Product Change Notification / SYST-25QQTY028

Data Sheet - VN1206 N-Channel Enhancement-Mode Vertical DMOS FET Data Sheet Document Revision

SYST-25QQTY028

4.1 Package Marking Information

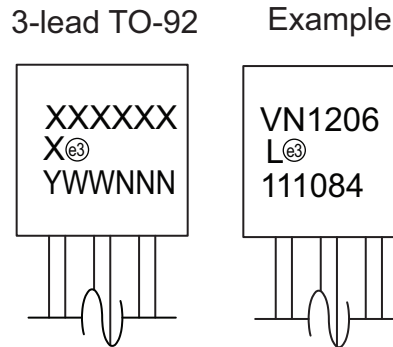
- 1) Converted Supertex Doc# DSFP-VN1206 to Microchip DS20005986A
- 2) Added a pin function table
- 3) Changed the package marking format
- 4) Removed the 3-Lead TO-92 L P003, P005, P013, and P014 media types to align packaging specifications with the actual BQM
- 5) Made minor text changes throughout the document
